Planning Department Alan Varela, Director

Re: Poblana Place Apts
2818 4<sup>th</sup> St. NW
30-Day Temporary Certificate of Occupancy
Transportation Development Final Inspection
Architect's Stamp dated 03-25-21 (H14-D111)
Certification dated 10-04-23

Re: Traffic layout certification, 2818 4th St NW, BP 2020-26464

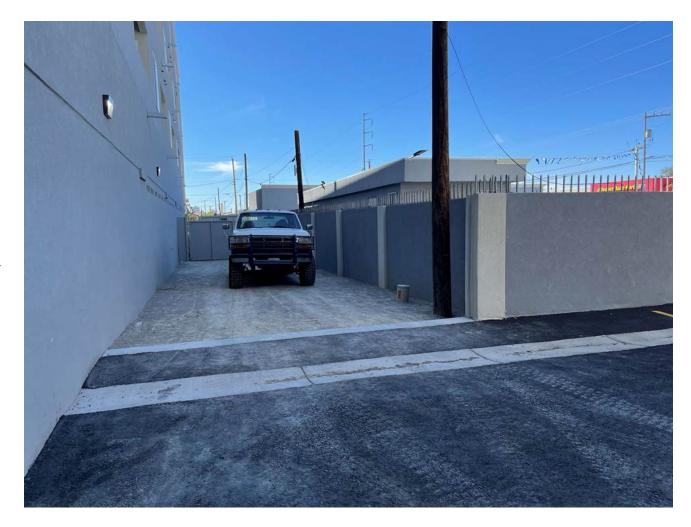
7. Per site visit only 13 parking spaces provided at this side of the site, the approved plan shows 16. Please provide 16 parking spaces.

8. The gate must be removed from the public Alley. Blocking City right of way is not allowed.

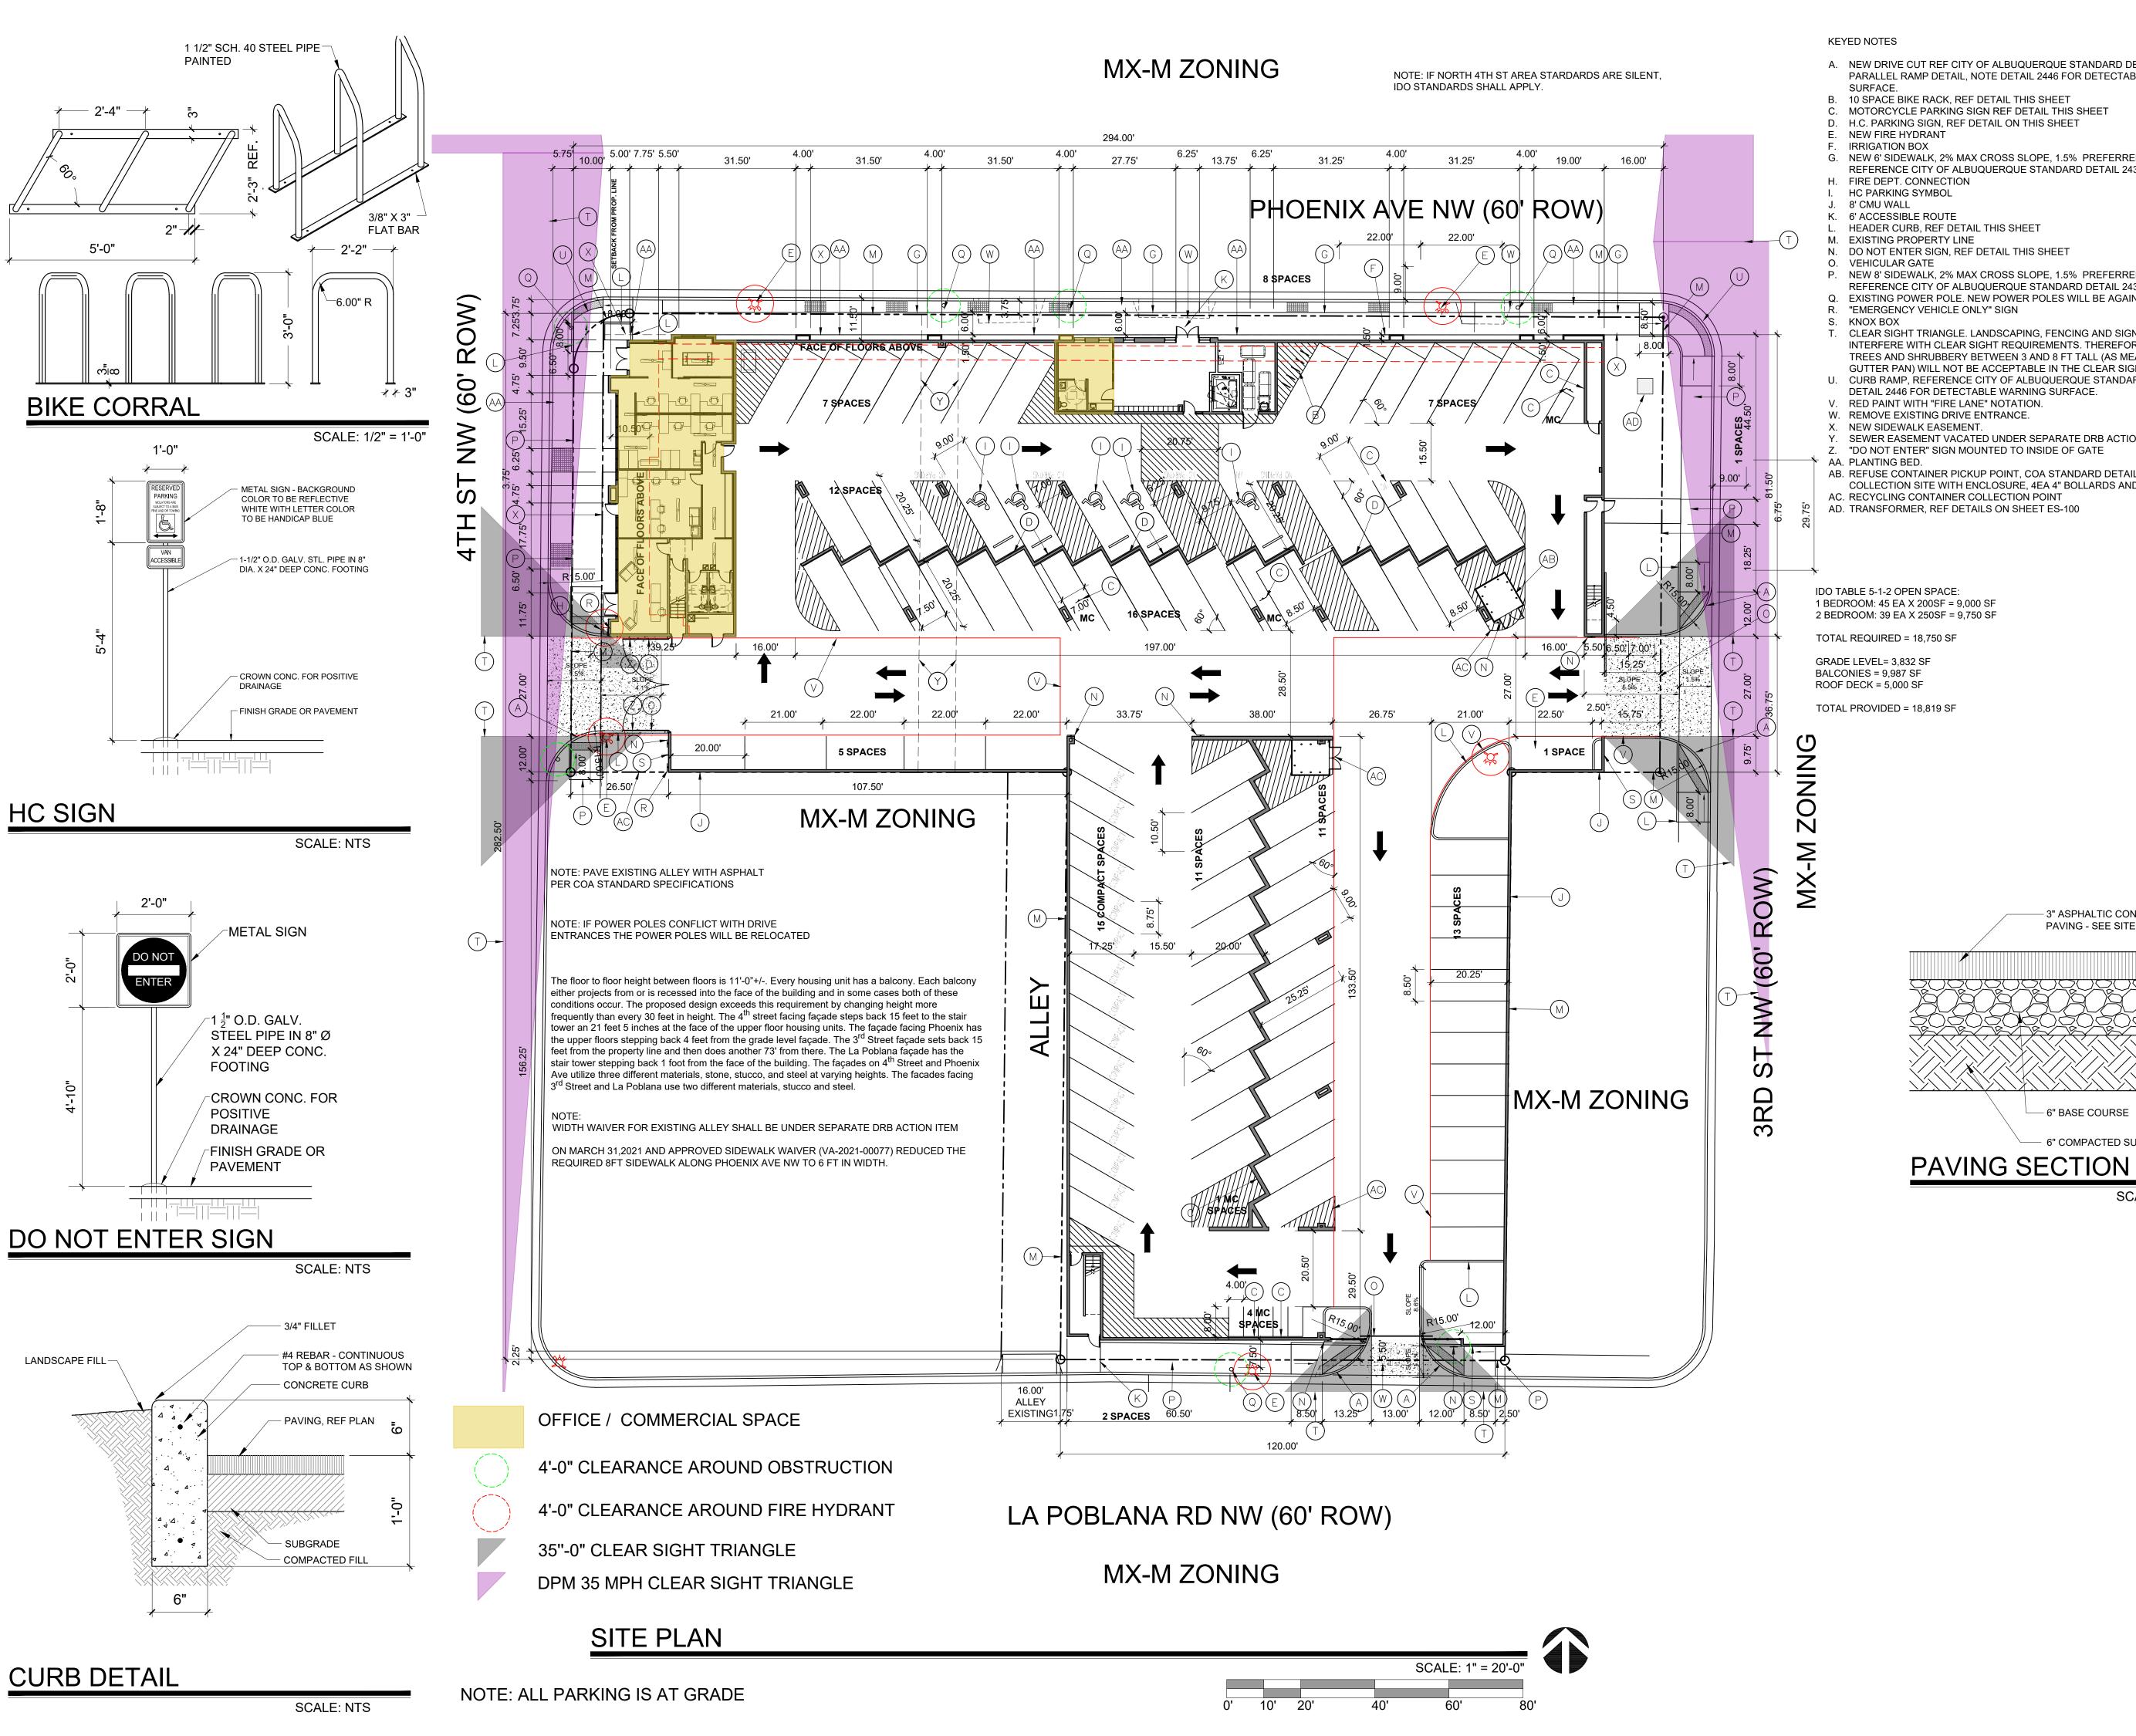
There is no striping on Phoenix Ave NW or 3<sup>rd</sup> St NW.

The finish floor elevation is higher causing a change to the door landing on the NW corner of the building.

A motorcycle parking space was relocated from the far NE corner of the garage to adjacent to a structural column.

The south side of the garage has 5 motorcycle parking spaces instead of 4.

One parking space was eliminated in the garage south of the building entrance and striped for pedestrian access.

There are no pavement markings on the fire access from 4th St.

There are no DO NOT ENTER pavement markings.
